Appeal No: PL-500109-WX

Summary Description
10 year planning permission for development of an Integrated Tourism Resort Complex. A Natura Impact Statement (NIS) and Environmental Impact Assessment Report (EIAR) has been submitted with the application.

Site Location
Beak and Nemestown, Kilmore Quay, Co. Wexford.

Integrated Tourism Resort Complex - Kilmore Quay, Co Wexford

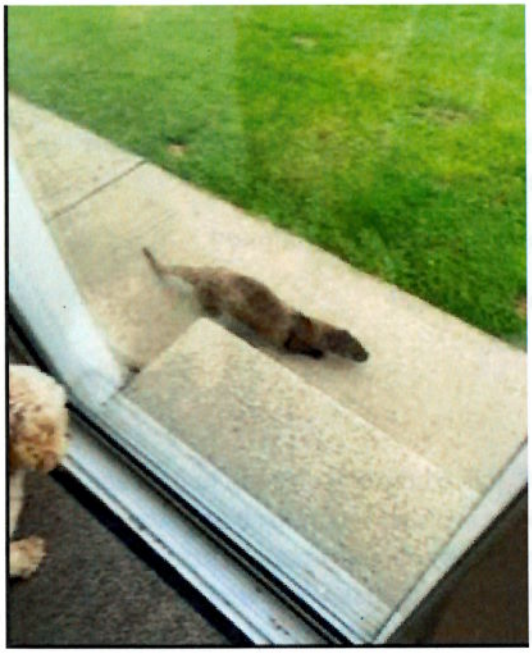
In addition buzzards are fully protected in Ireland under the Wildlife Act, 1976, and the EU Birds Directive. Buzzards have been identified on the proposed development site also (see photograph below with St Patrick's Bridge in the background). Again, it is unclear why reference to this protected species which is present in the area was omitted from the Developer's report.
